# PERMIT

## SEWAGE DISPOSAL SYSTEM

SUBDIVISION Holiday Hills LOT 62, Sec. 5 ROAD 10826 Hunting Lane

REPAIR - PURPOSE - TO MOVE SEPTIC TANK TO SUITABLE LOCATION FOR PROPOSED ADDITION. (No. 44984)  
CALL FOR INSPECTION WHEN TANK IS IN PLACE SO THAT A SANITATION CAN APPROVE THE LOCATION.  
8/10/92

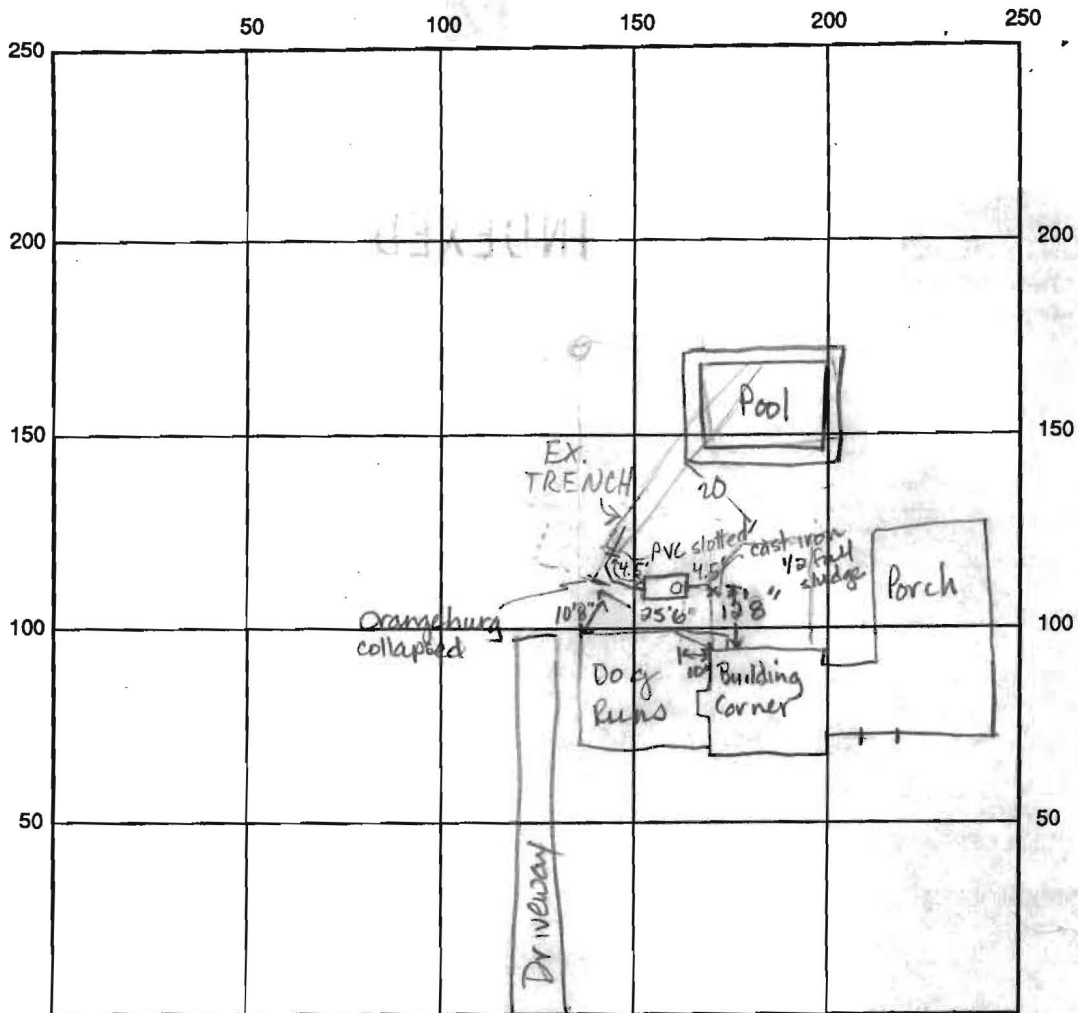
REMARKS: 8-31-92 septic tank moved to 10ft from existing home and proposed addition. JEN

Call for inspection when trench is located. JEN

9/1/92 ALL LINE CONNECTIONS OK; LOC. OF OPERATIONAL TRENCH VERIFIED; BP PROPOSAL MODIFIED TO ALLOW FOR 20' SETBACK; MR

PROPOSED ADDITION FOR  
MR & MRS BRIMSON SYKES  
10826 HUNTING LANE

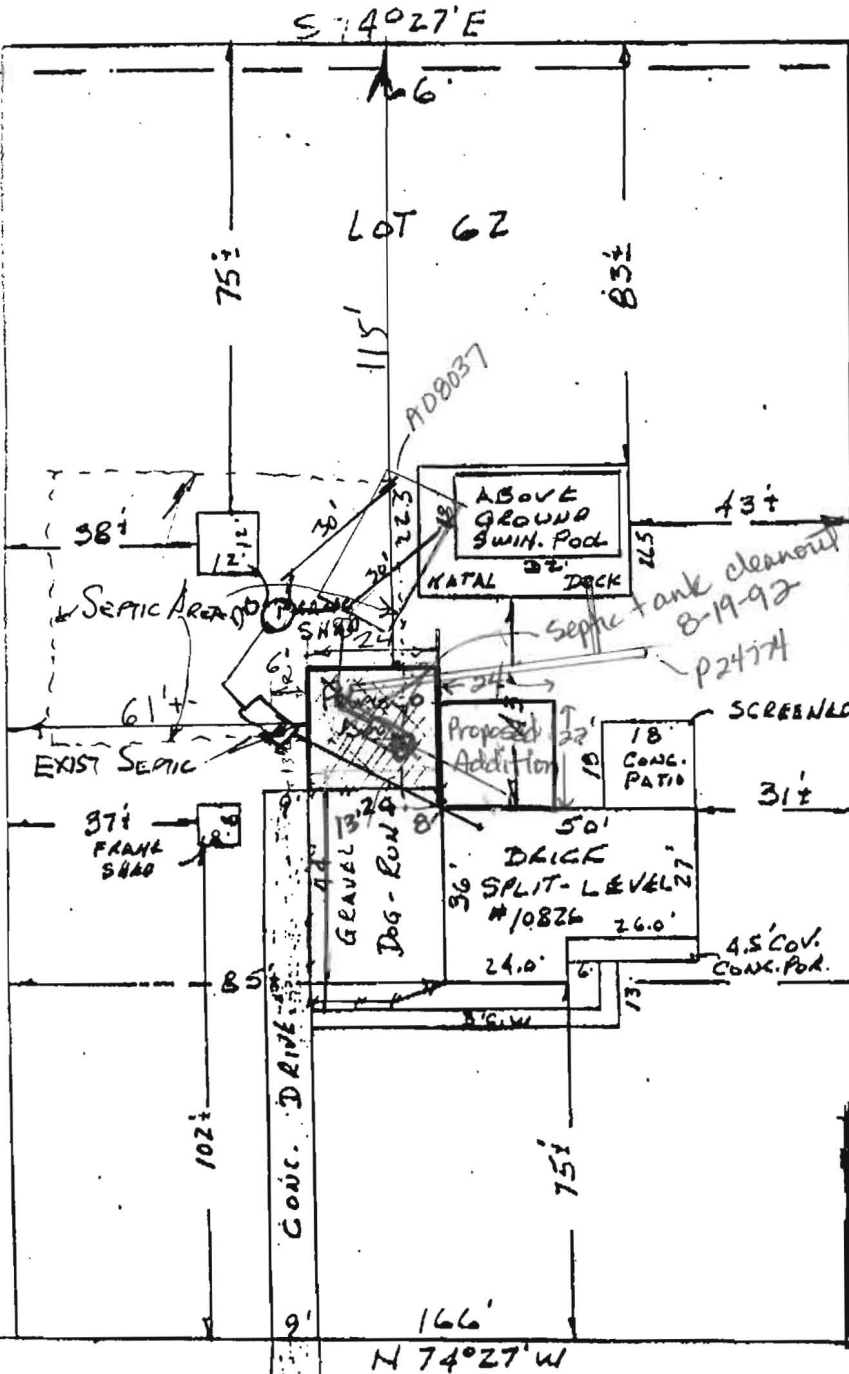
8-19-92  
Approximate location of septic trench is between addition and pool, would require abandonment of trench. ~~as~~ as well as septic tank relocation. JEN

JENadeau  
PROPOSED ADDITION FOR  
MR & MRS BRANSON SYKES  
10826 HUNTING LANE

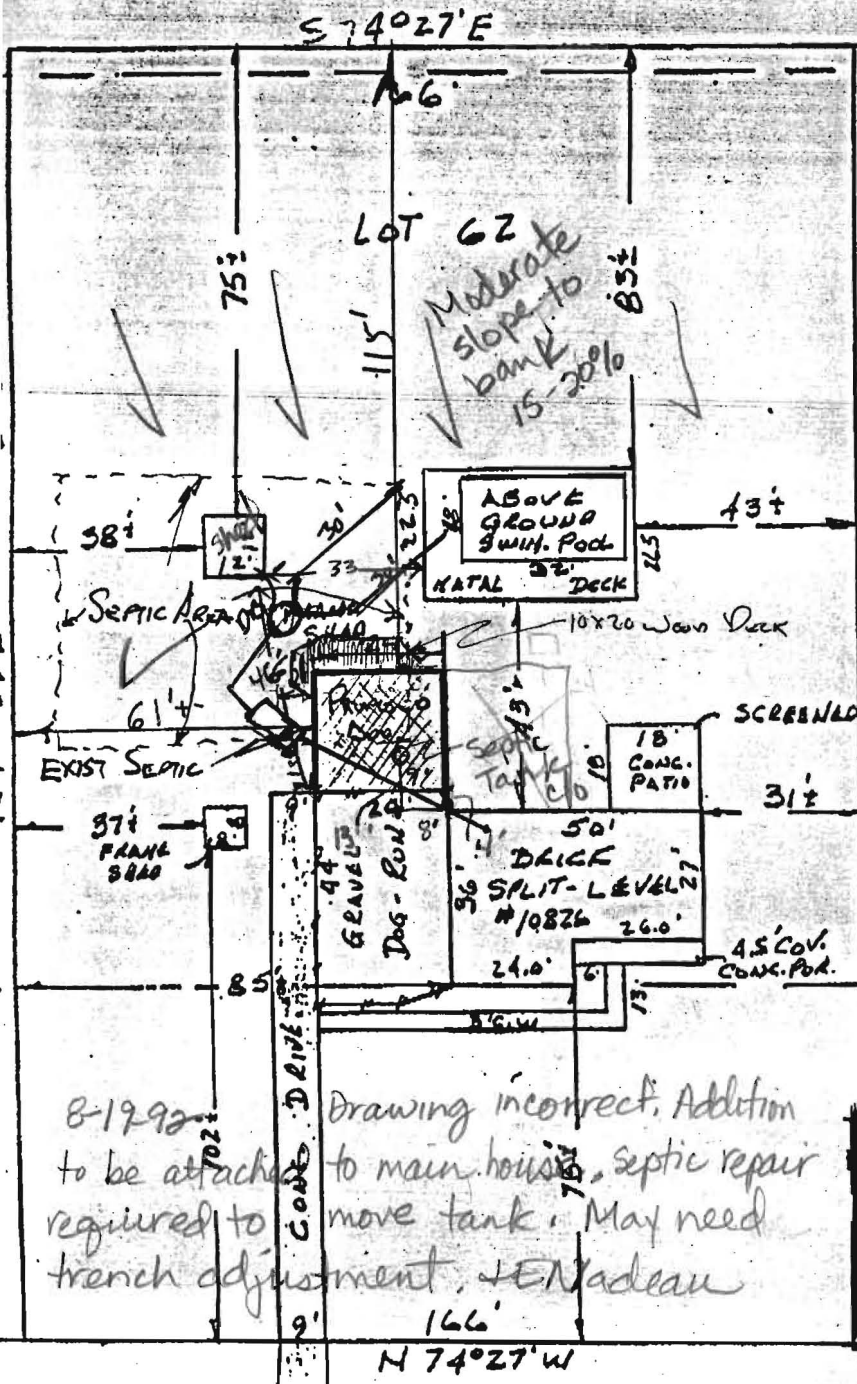
8-12-92  
Septic tank clean out is not as shown. Appears to be in center of proposed addition. Trenches appear to dead end along lower edge of pool when facing from back of house.

Unclear if pool and shed are both on SDA easement. No well could be located.

Recommend repair to increase septic system and L75B.R.L. confirm area for repairs.

8-19-92  
Drawing incorrect. Addition to be attached to main house. Septic repair required to move tank. May need trench adjustment. JENadeau
